# COUNCIL ADDENDUM TO SUPPLEMENTARY REPORT

<b>Panel Reference</b>	PPSHCC-142
<b>DA Number</b>	Mod2022/0062
<b>LGA</b>	MidCoast Council
<b>Proposed Development</b>	<ul style="list-style-type: none"> <li>• Modifications to development staging (stages 2, 3 and 4)</li> <li>• Alterations to the basement, ground, ground level floor plans</li> <li>• Removal of hotel use and the provision of retail space and seniors housing</li> </ul>
<b>Street Address</b>	34-36 West Street, Forster NSW
<b>Applicant/Owner</b>	Enyoc Pty Ltd (Applicant) Midcoast Council (Owner) Evermore Supported Living Communities Pty Ltd (Owner)
<b>Panel Meeting Dates</b>	12 July 2023 & 12 September 2023
<b>Issues</b>	Calculation of Gross Floor Area Calculation / Allocation of Carparking Ceiling Heights Draft Conditions
<b>Prepared by</b>	Bruce Moore Coordinator Major Assessments MidCoast Council

### **GROSS FLOOR AREA CALCULATIONS**

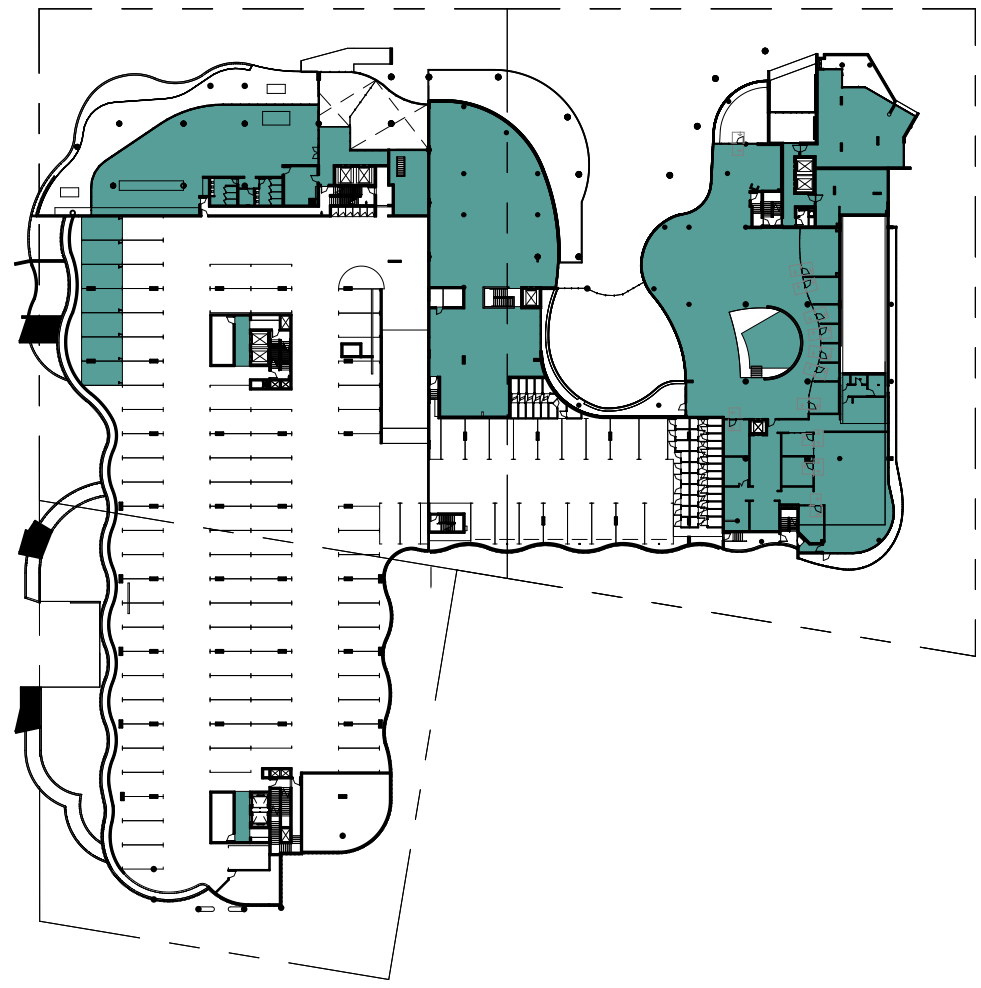
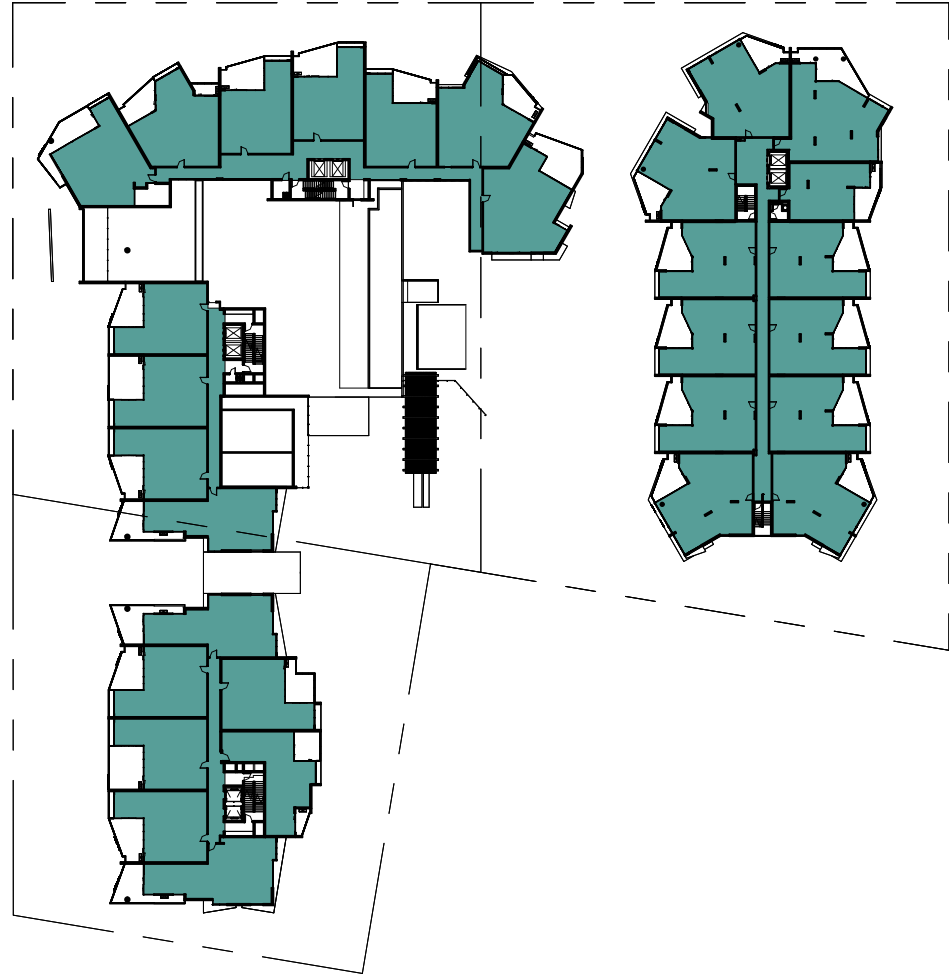
Individual floor plan sheets showing the area included in the Gross Floor Area Calculations have been provided and attached as Annexure A. In summary the calculation sheets show:

Level 2 Floor Plan

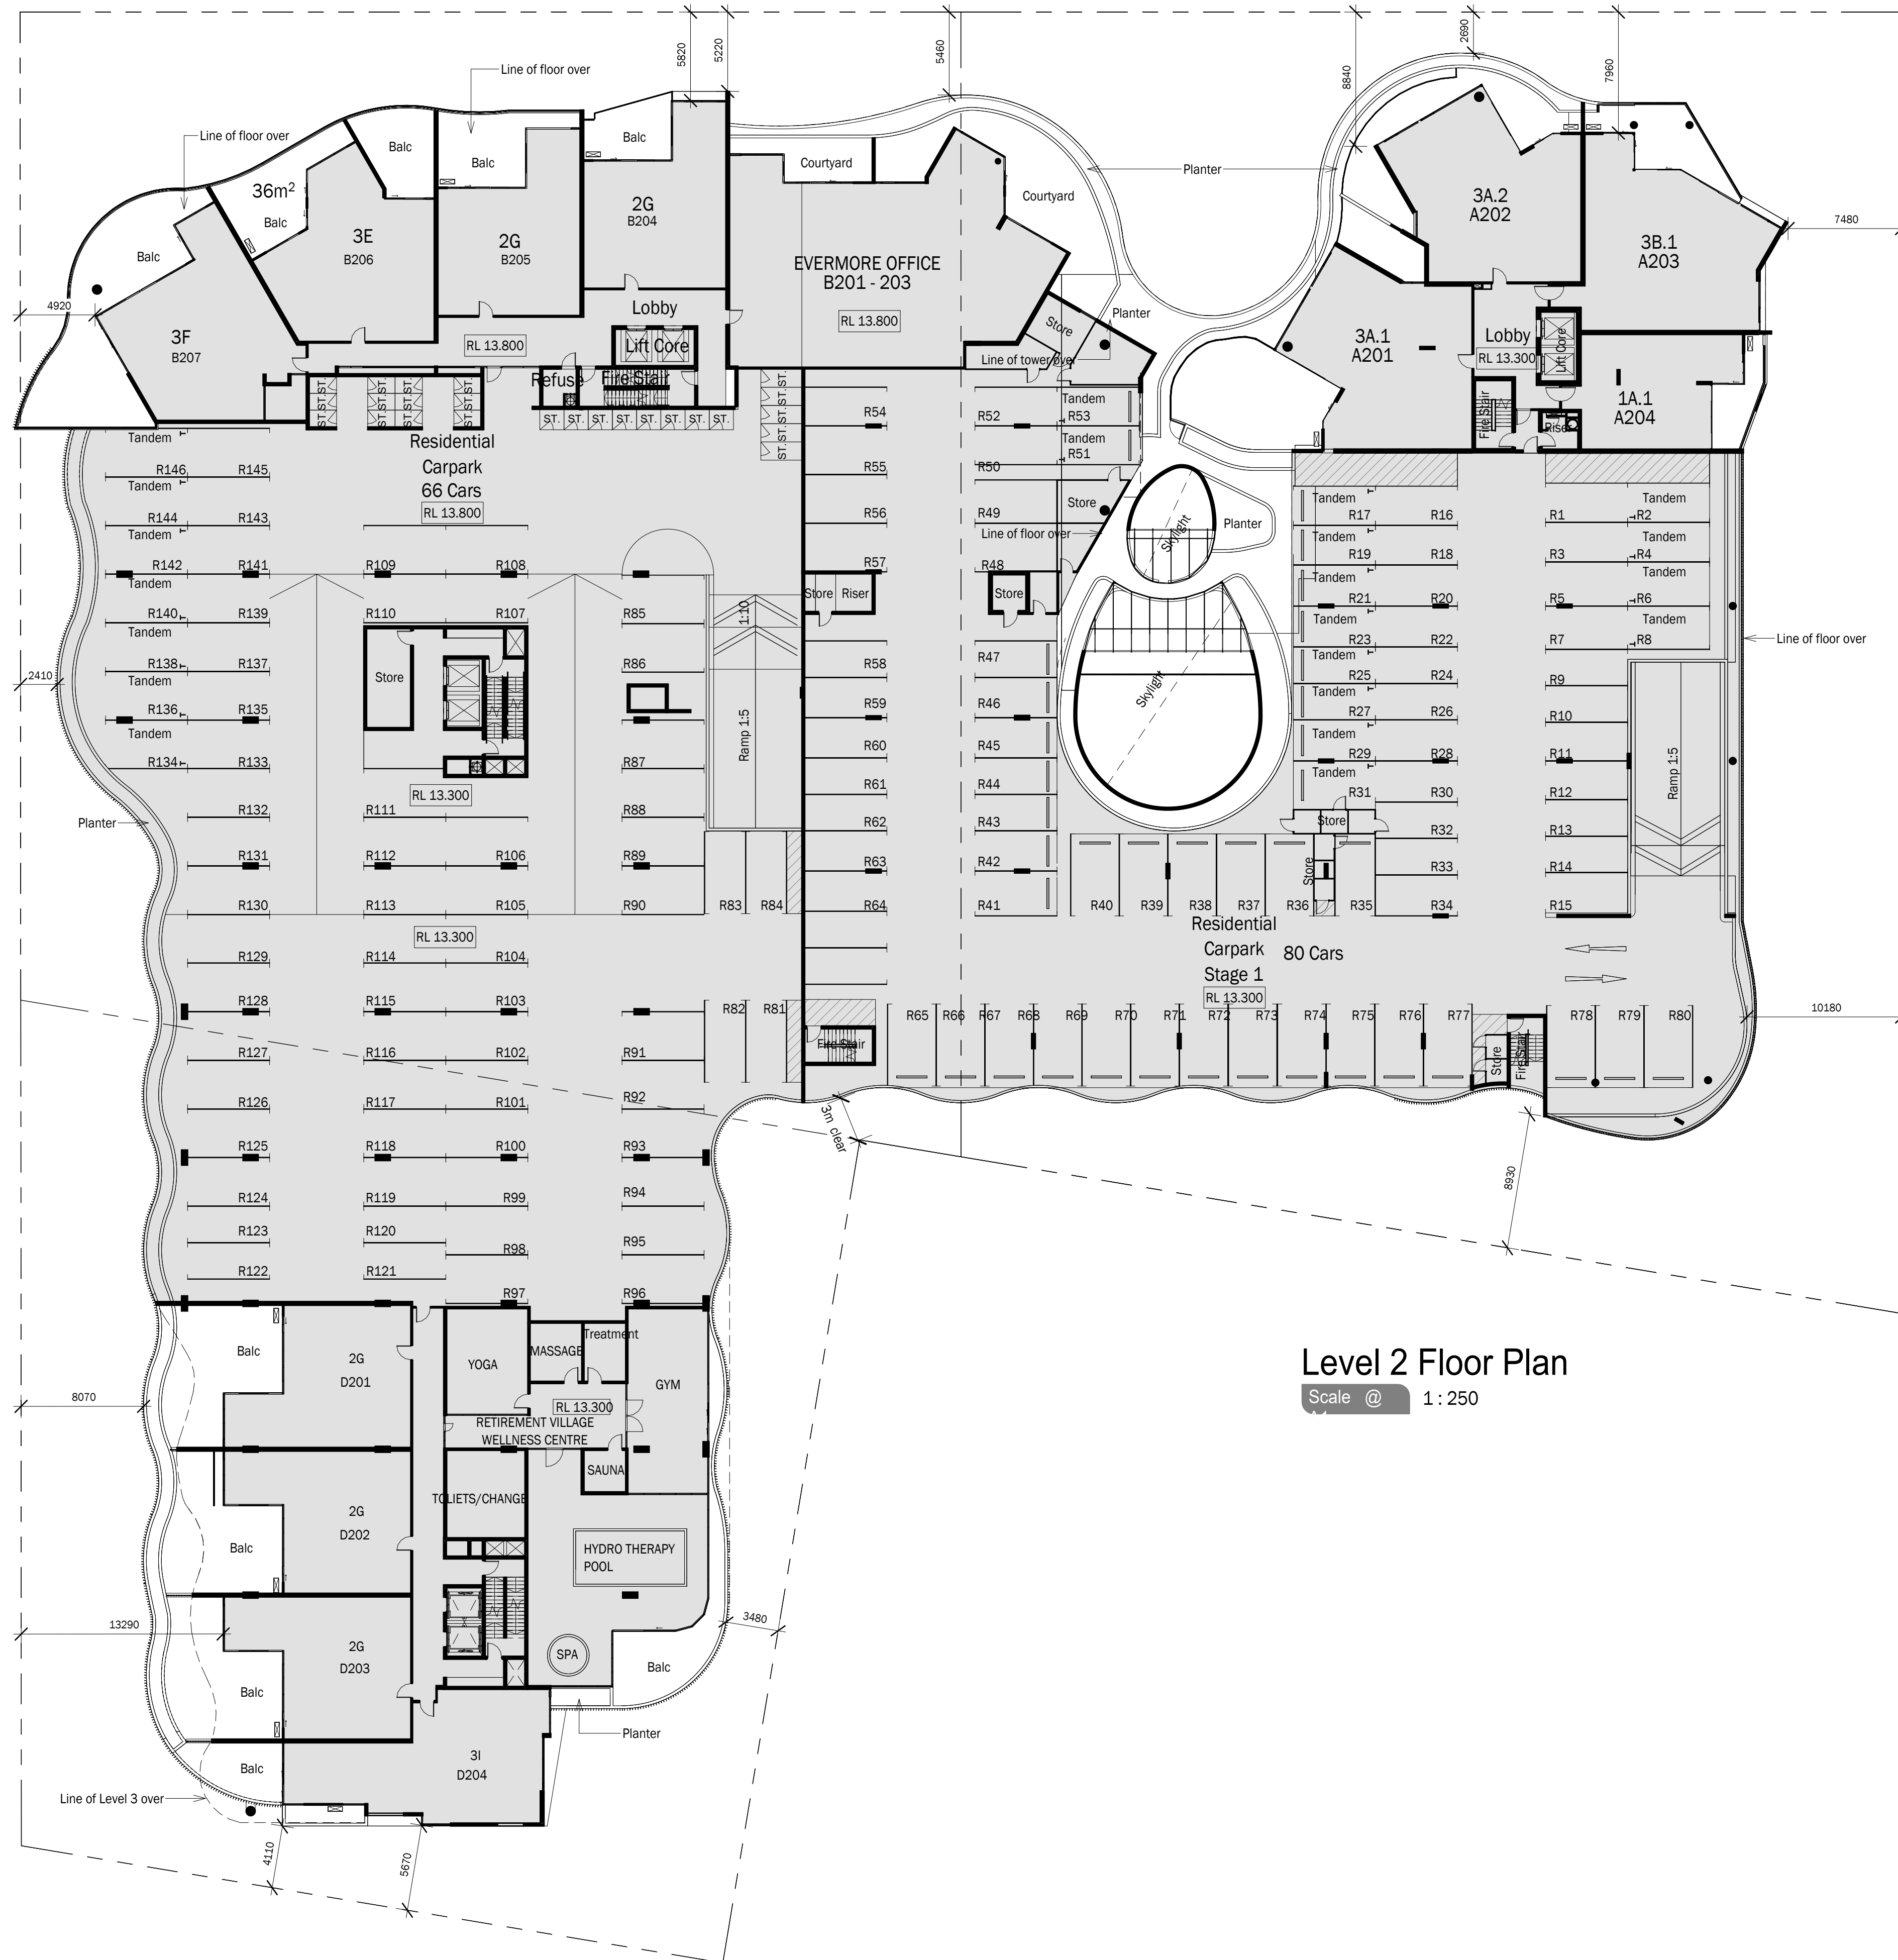
In keeping with comments made by the Panel, the applicant has provided detail (Annexure C) of a wall separating the residential and seniors parking areas at Level 2. The inclusion of the wall defines the relevant parking areas and has no adverse impact on access or manoeuvrability.

## Typical Unit - (2H) Stage 3

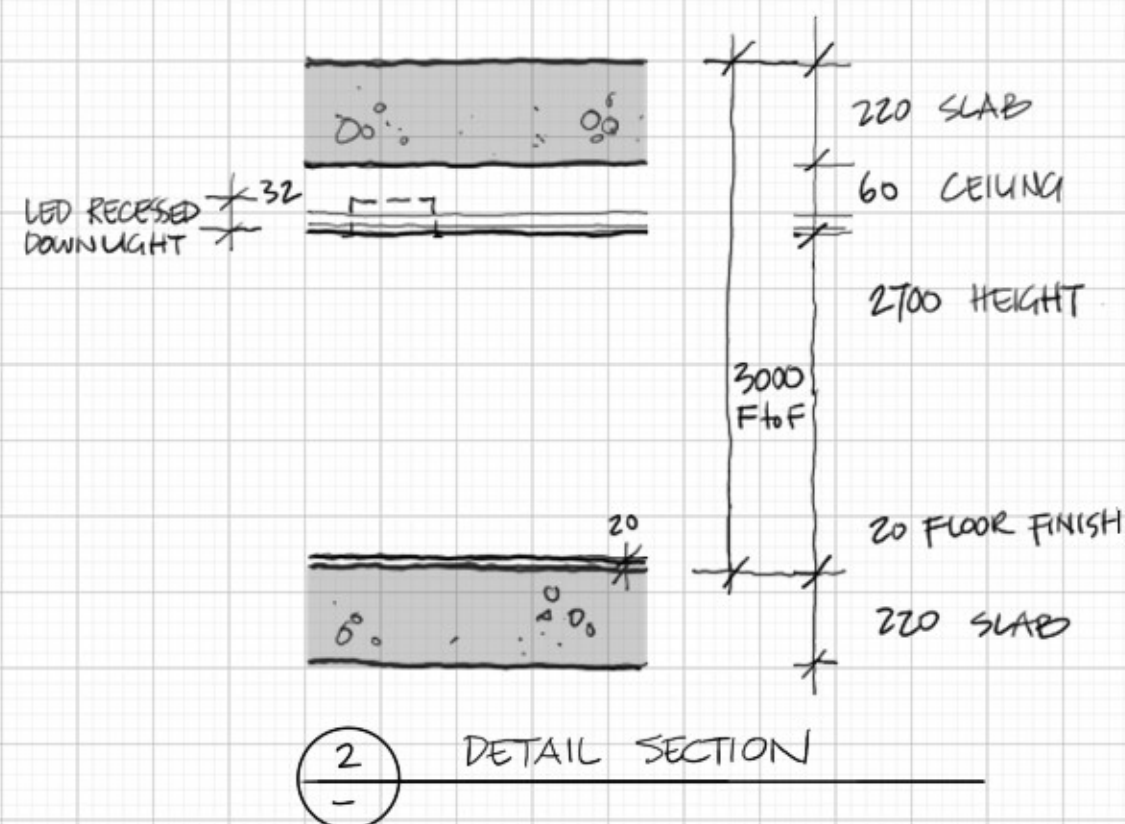
The applicant has provided detail (Annexure D) to demonstrate that a 2.7m ceiling height can be provided for all habitable spaces (living rooms/bedrooms etc.) with a 2.4m ceiling height provided for the bathroom and laundry areas to accommodate services.

The proposed design for the above project has 3 m Floor-to-floor heights nominated on the DA drawings for the residential towers. We confirm that 2.7 m clear ceiling heights can be achieved in habitable unit areas with these nominated heights. This is a standard Floor-to-Floor height used previously on many residential projects completed by TVS, in which case 2.7 m clear ceiling heights have been achieved. We generally use 200-220 mm thick floor slabs with 20 mm for floor finishes and 60 mm for ceiling lining, framing and lights (32 mm deep). Services such as mechanical ventilation and plumbing are housed in wet areas (bathrooms and laundries) with 2400 mm dropped ceiling spaces or bulkheads in these non-habitable rooms. This is an NCC-compliant arrangement and shall not encounter any problem with the certification of the building for Building Approval.
